# AD20-21

## 2018 Virginia Building and Fire Code Related Regulations

## 2018 Virginia Building and Fire Code Related Regulations

Figure 7. Locations where design for tornado loads is not required for a Risk Category III building or other structure having an effective plan area  $A_e = 100,000 \text{ ft}^2$ , located in Exposure B (top) and Exposure C (bottom).

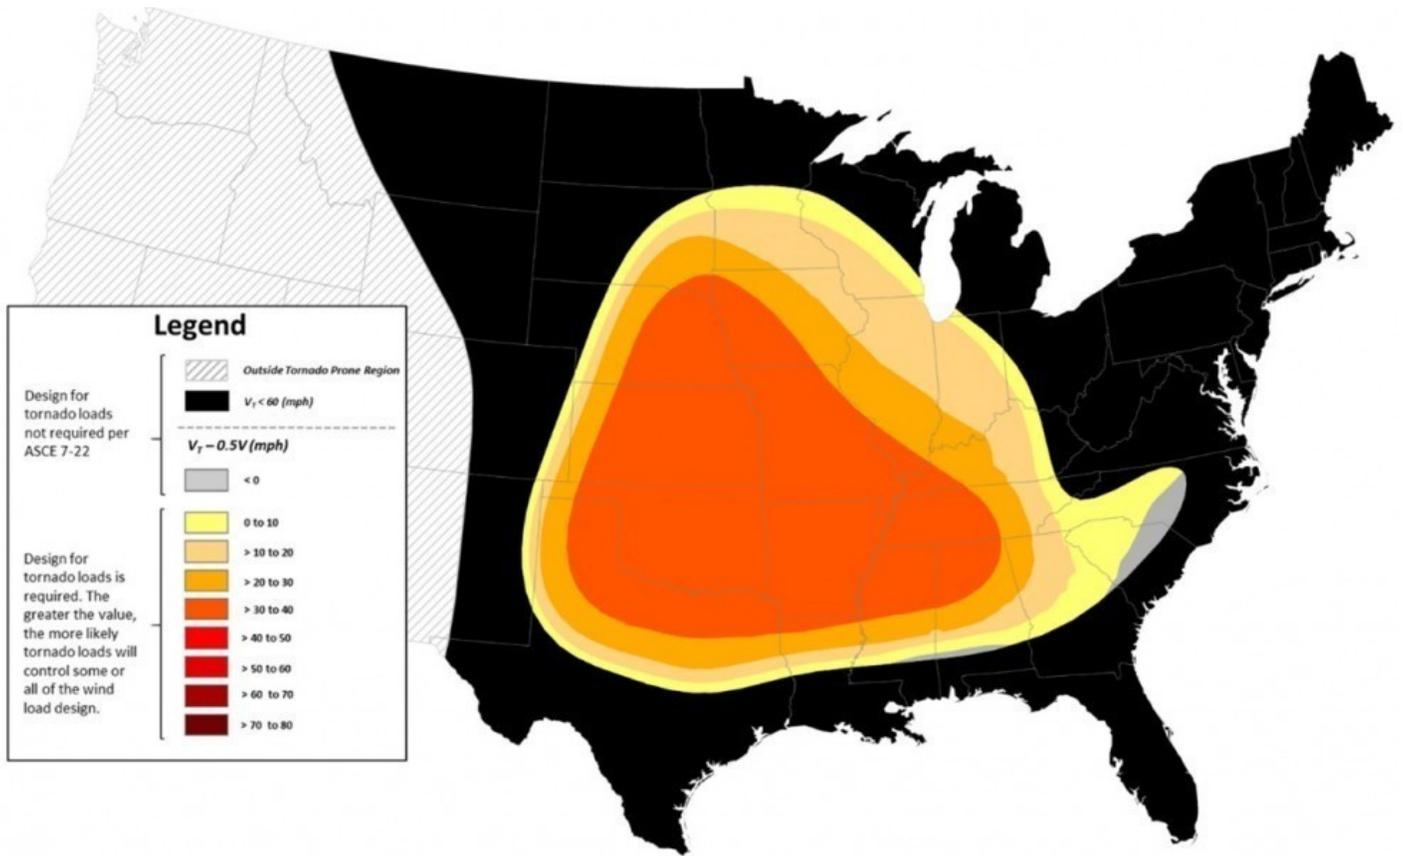
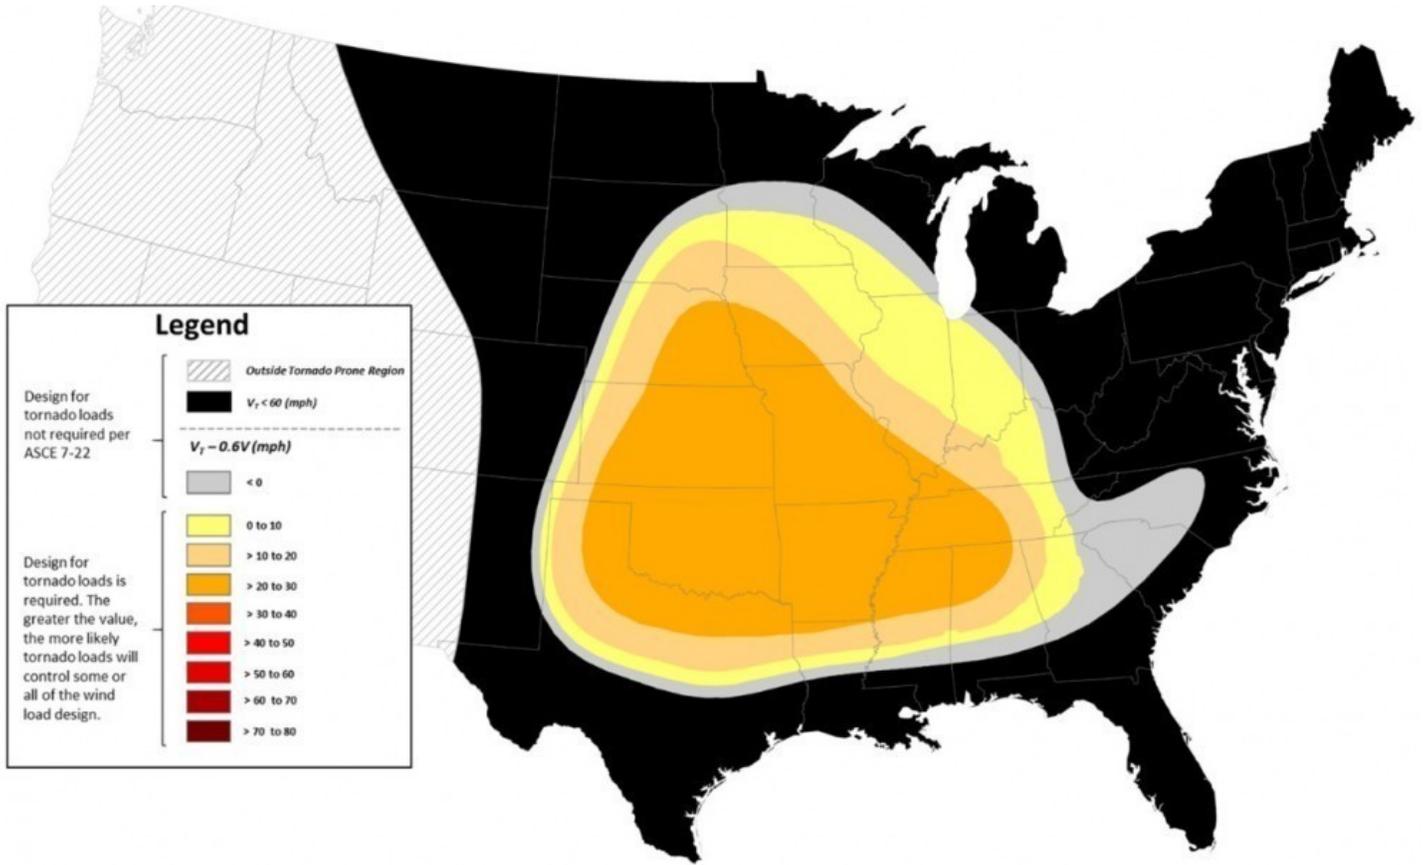
For a medium-sized Risk Category III building, the tornado speeds are less than 60 mph across much of the tornado prone region (Figure 7). Tornado loads are required only in the areas shaded with the warm colors, which spans roughly between north Texas, central Minnesota, and the central Carolinas. In contrast, tornado loads are required across most of the tornado-prone region for very large Risk Category IV facilities, except New England and small areas of south Florida and south Louisiana for Exposure C (Figure 8). In both figures, the darker reds indicate areas that tornado loads are more likely to exceed wind loads. In general, tornado loads are more likely to control at least some element(s) of the wind load design for buildings and other structures that have one or more of the following characteristics:

Figure 8. Locations where design for tornado loads is not required for a Risk Category IV building or other structure having an effective plan area  $A_e = 1,000,000 \text{ ft}^2$ , located in Exposure B (top) and Exposure C (bottom).

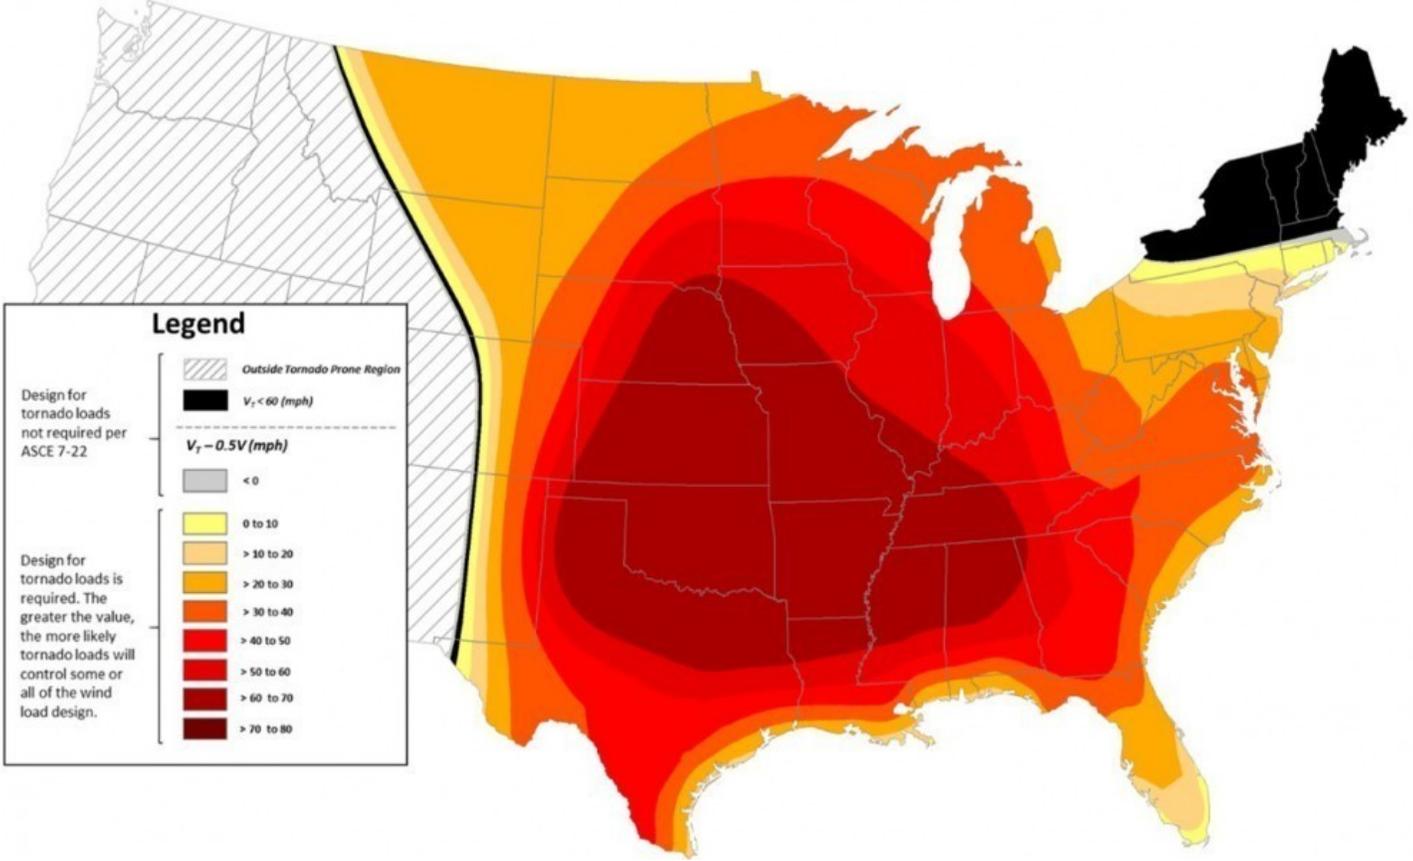
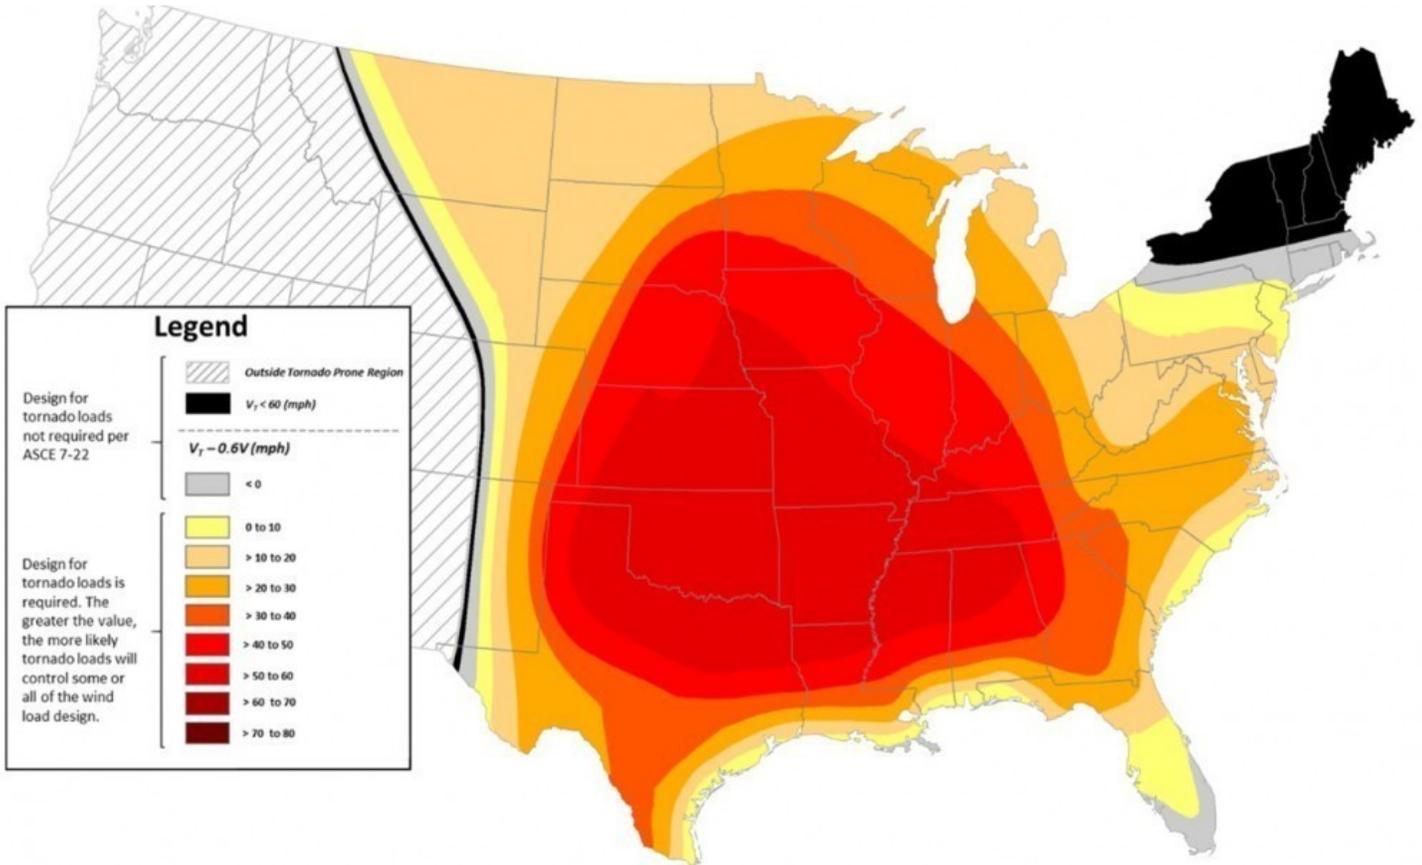
Maps were created to show where design for tornado loads is not required, based on the tornado speed criteria in the previous paragraph. Examples for a medium size Risk Category III facility and a very large Risk Category IV facility are shown in Figures 7 and 8, for both Exposures B and C. At locations where the tornado speed is greater than the specified percentage of the basic wind speed, design for tornado loads is required but may still not control. This is because the net pressure loading patterns on a building are different for tornadoic versus non-tornadoic winds, due to the differences in wind and wind-structure interaction characteristics which are reflected by factors 4 through 8 above.
